Title: Additional Information

Project: MPPT V1.2 Afonso PrjPeb Version: 3

Company: Técnico Solar Boat

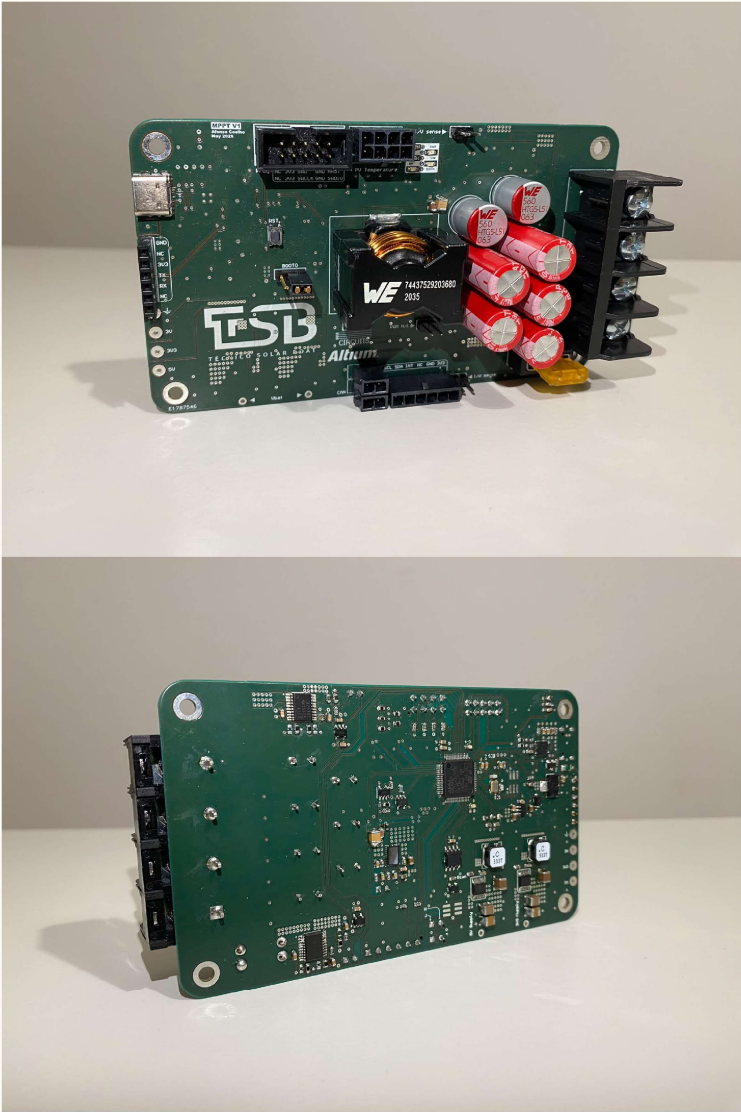
Differences between V1 and V1.1:

- Solved UARTH signals swapped;
- Usb working;
- 3D model correction of main connector;
- 5V in programming port;
- 5V in or gate;
- Label sizes;
- Added diodes to power electronics circuit (increased eff);
- Added diodes in DCDCs for reverse current protection;
- Reduced pcb cost;
- Added FANs connector;

Differences between V1.1 and V1.2:

- Added capacitors to filter the high frequency noise generated by the switching converter;
- Changed the placement of the filters to reduce measurements noise;
- Fixed the missing 5V label in the flash connector;
- Changed the led labels;
- 0 Ohm resistors in current sensor circuit removed;
- Added a capacitor for Tfet measurement
